PLANNING COMMISSION AGENDA

June 5, 2017

To: Chair Ronningen and members of the Planning Commission
 From: Ron Moorse, City Administrator
 Date: May 23, 2017
 Re: Will Carlson Afton Creek Preserve Sketch Plan for a Preservation and Land Conservation Development Subdivision North of 60th Street and West of Trading Post Trail – **Public Hearing**

SUBJECT: Afton - Afton Creek Preserve Sketch Plan

SKETCH PLAN - SCENIC OVERLOOK CONCEPTS

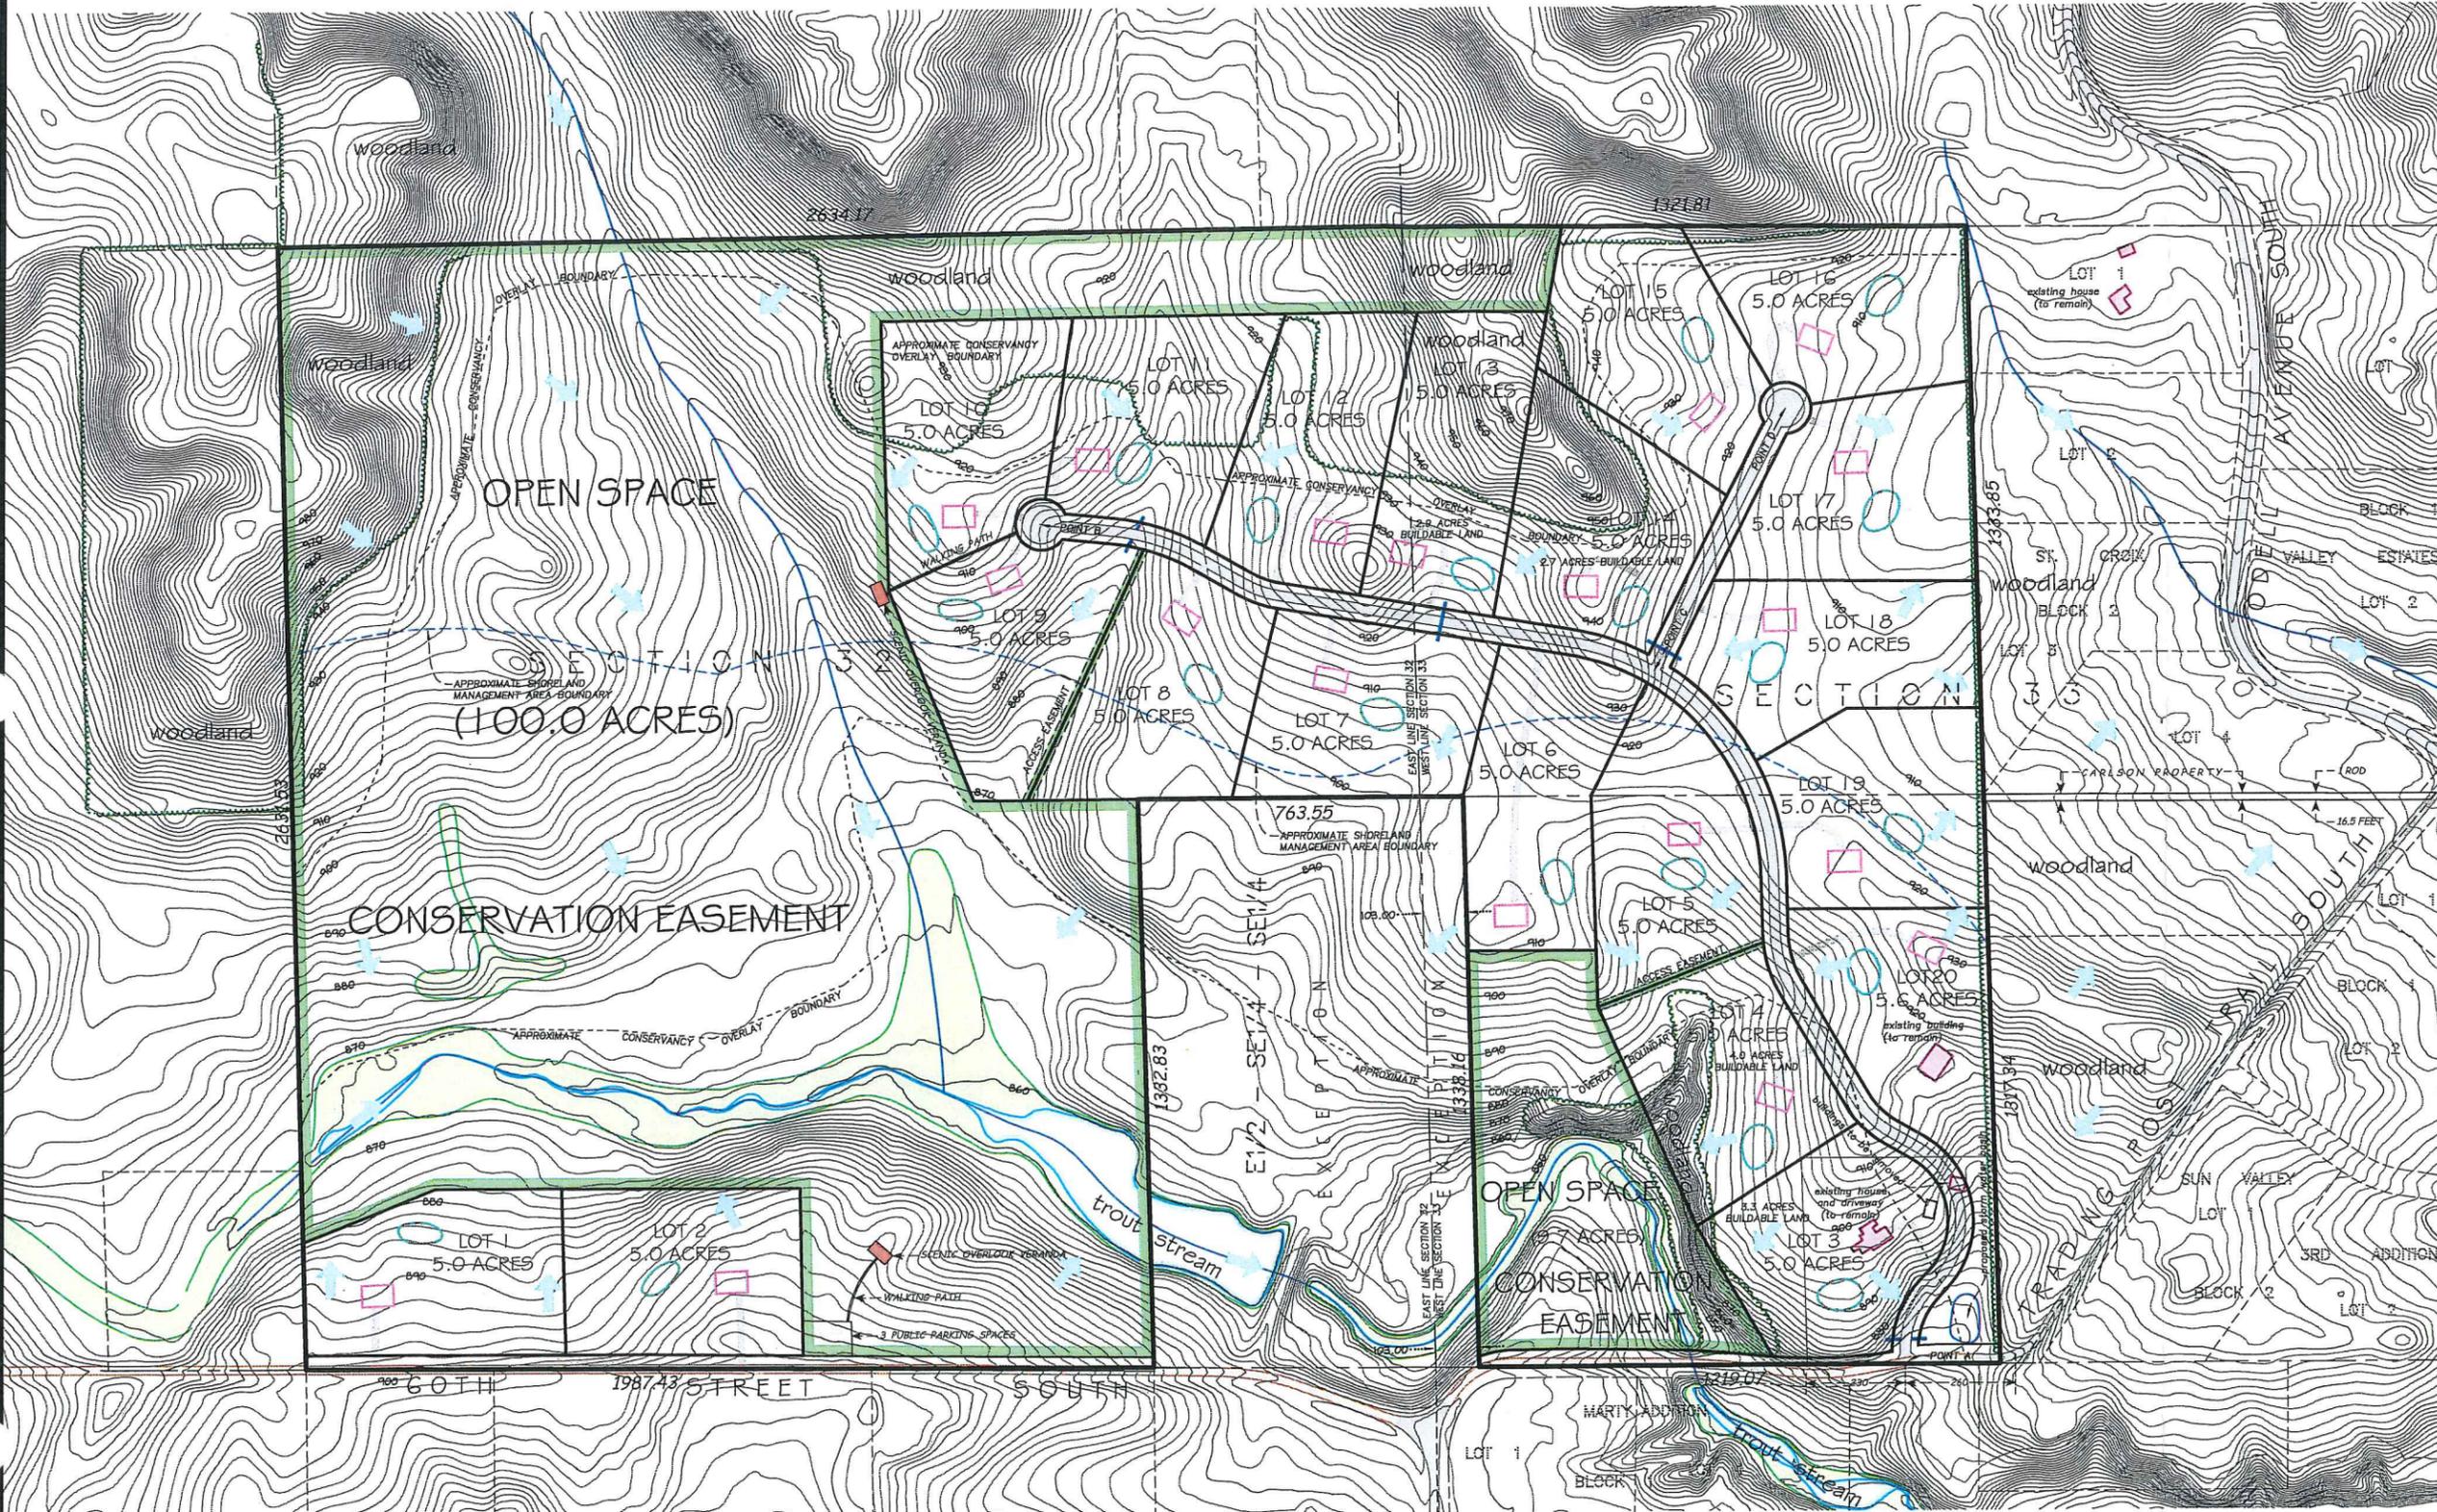
REVISED MARCH 01, 2017: Revised main road entrance location.
REVISED MARCH 31, 2017: Added approximate Conservancy Overlay boundary per City of Afton 2010 Zoning Map, Map 11.
REVISED MAY 05, 2017: Revised Lot 1, labeled buildable area on Lot 3, Lot 4, Lot 13 and Lot 14, mapped 1 rod strip of land in Section 33.
REVISED MAY 23, 2017: Revised map title, legend and added proposed bike trail and related information.
REVISED MAY 30, 2017: Revised map title, legend, removed bike trail, added scenic overlook concepts.

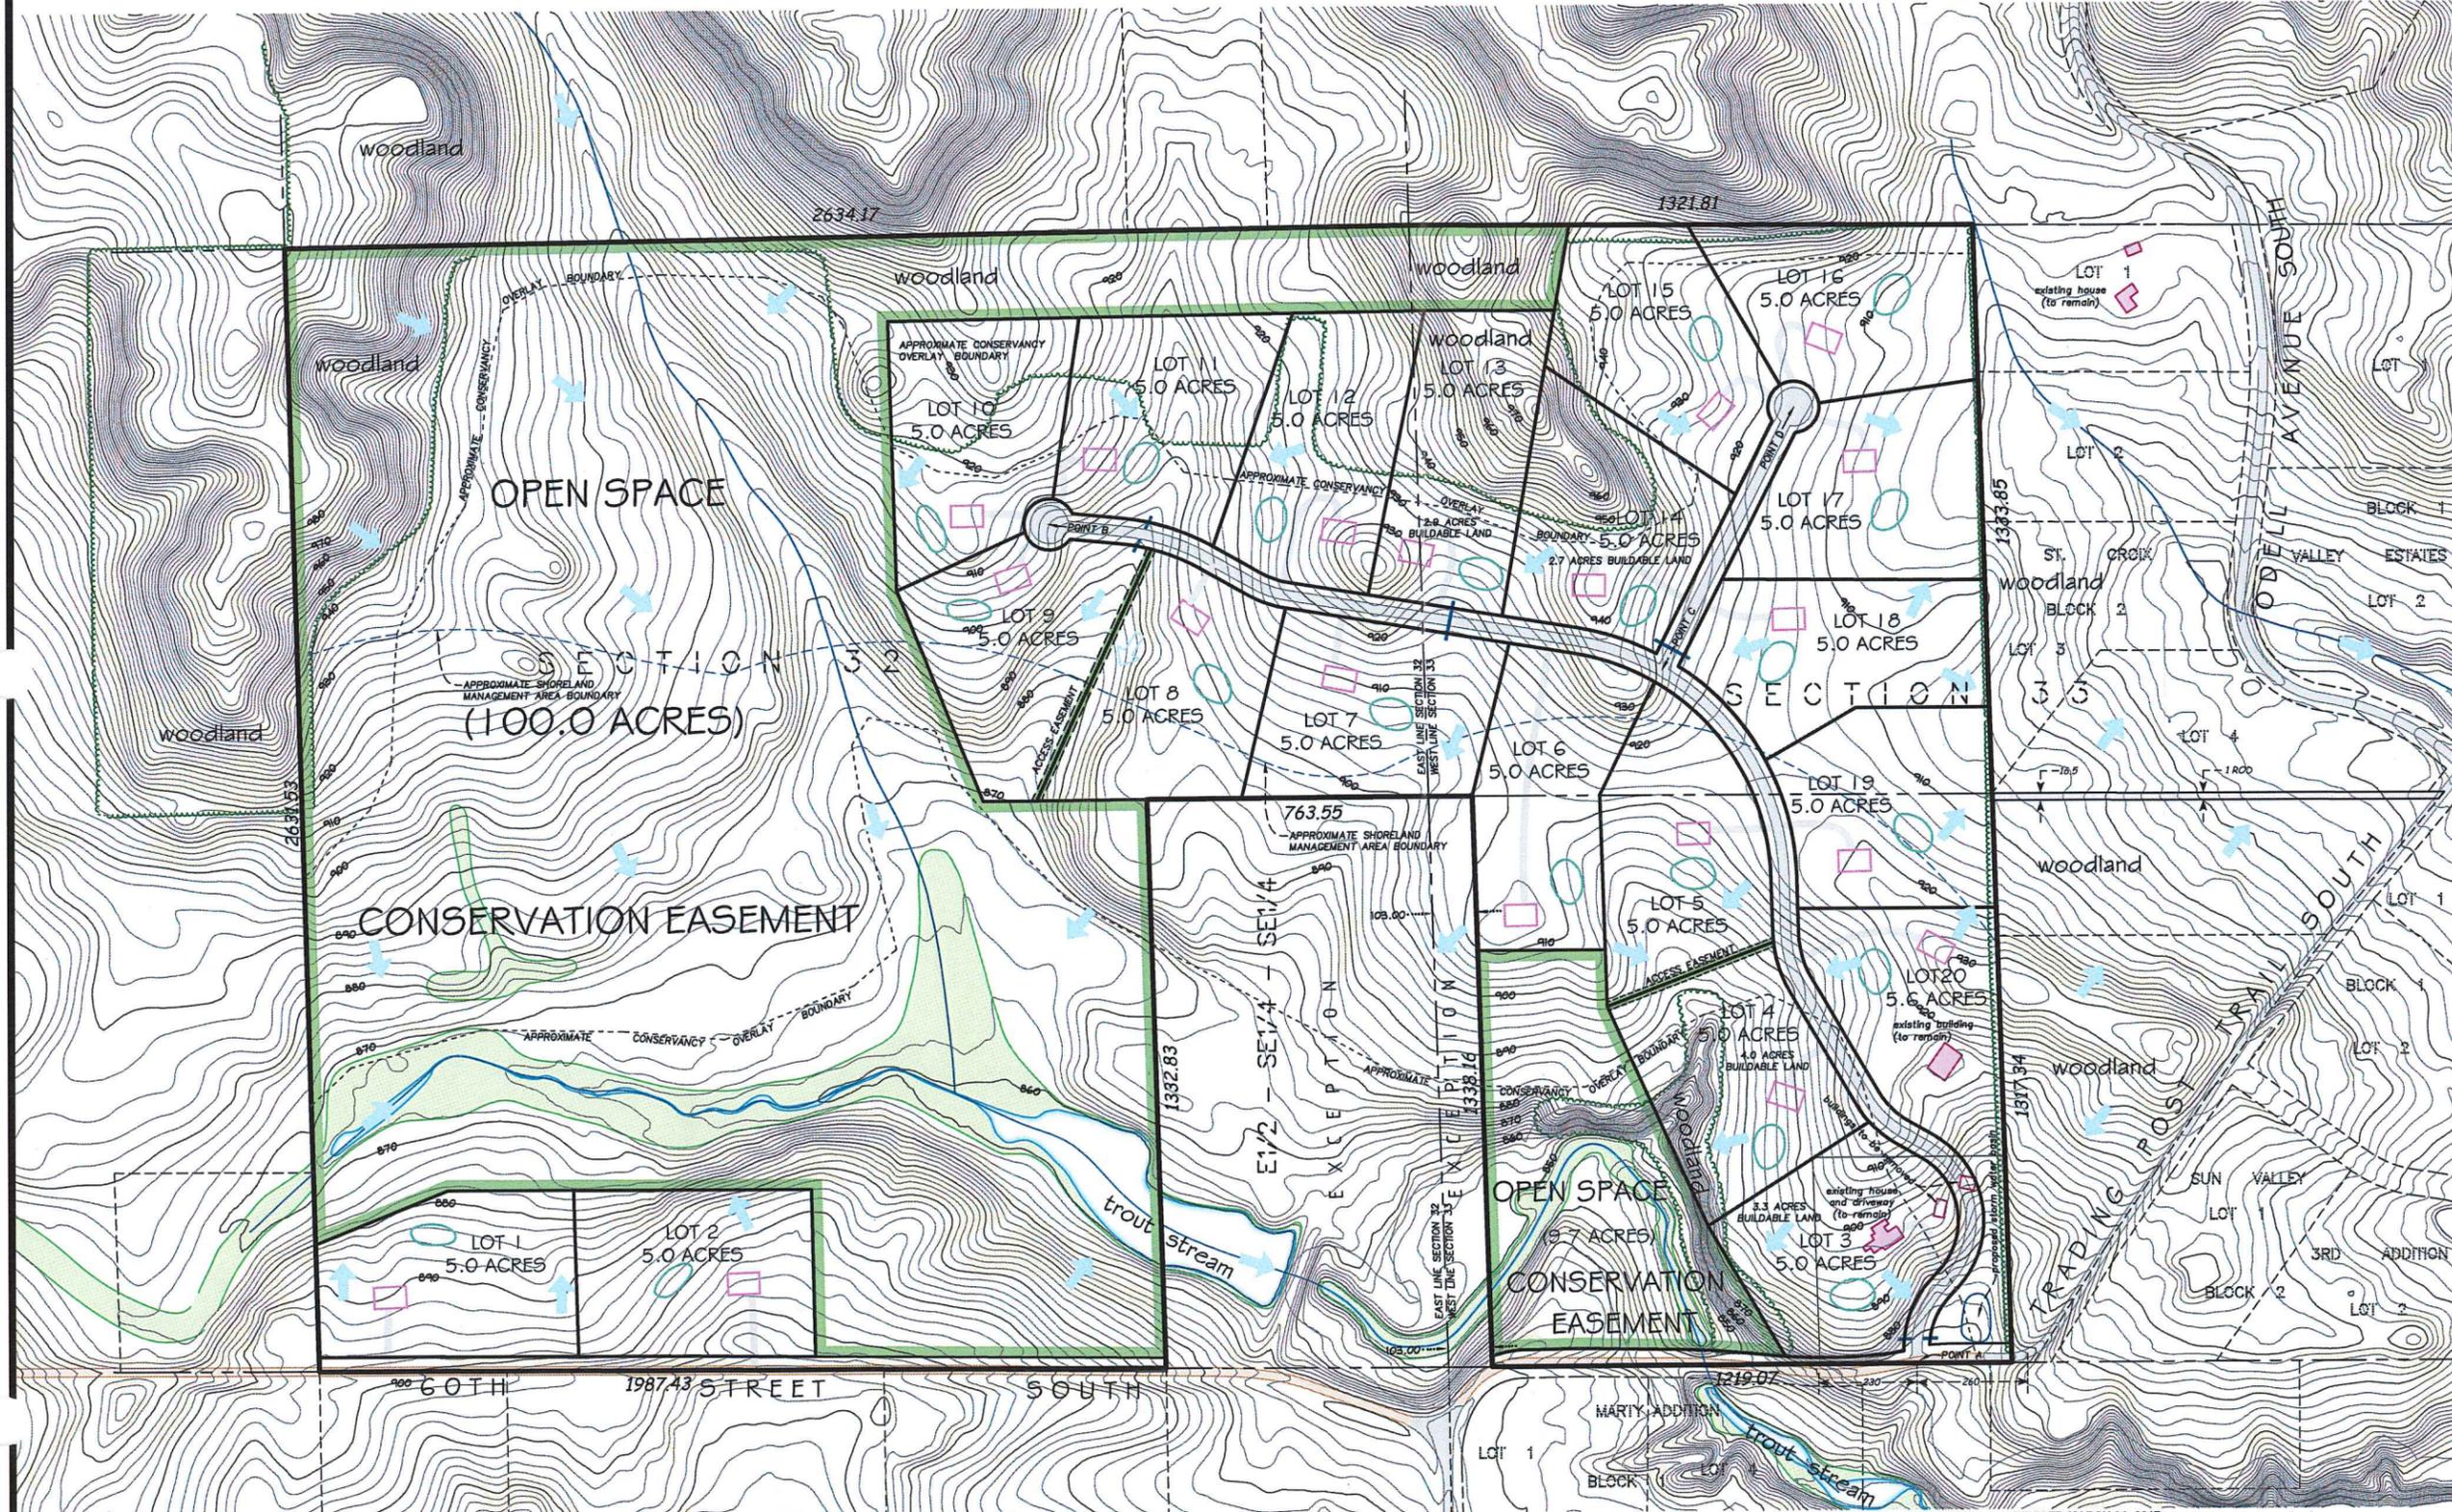
Proposed Length of Cul-De-Sac -
Point A to Point B = 3,400 lineal feet
Point C to Point D = 690 lineal feet

Figure 3 - Post-Construction Site Plan

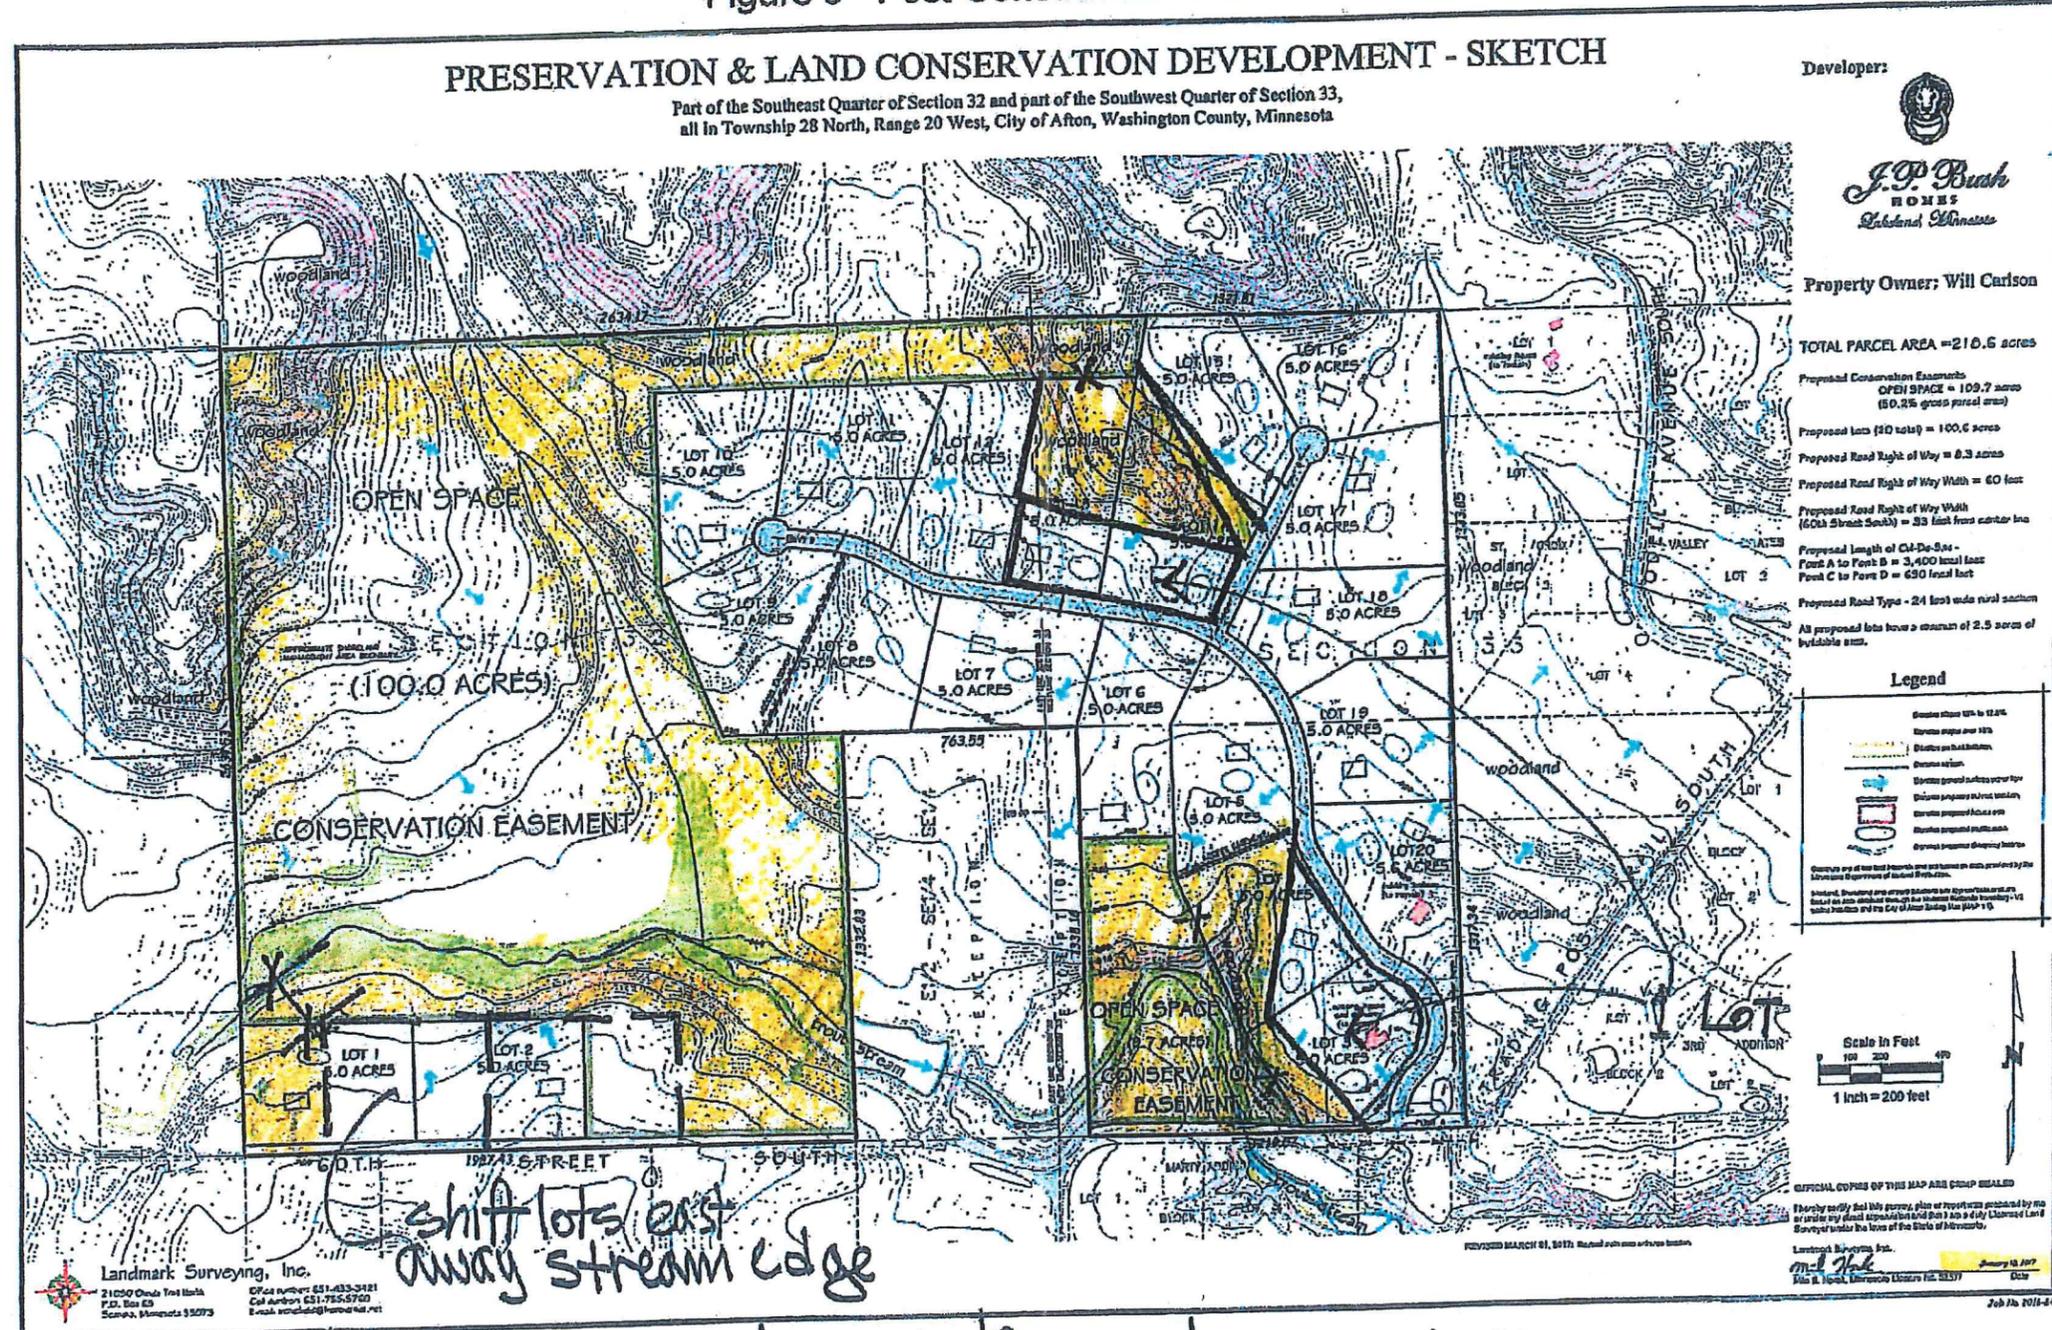
*Bake Baker's
Layout modifications*

*Shift lots east
away stream edge*
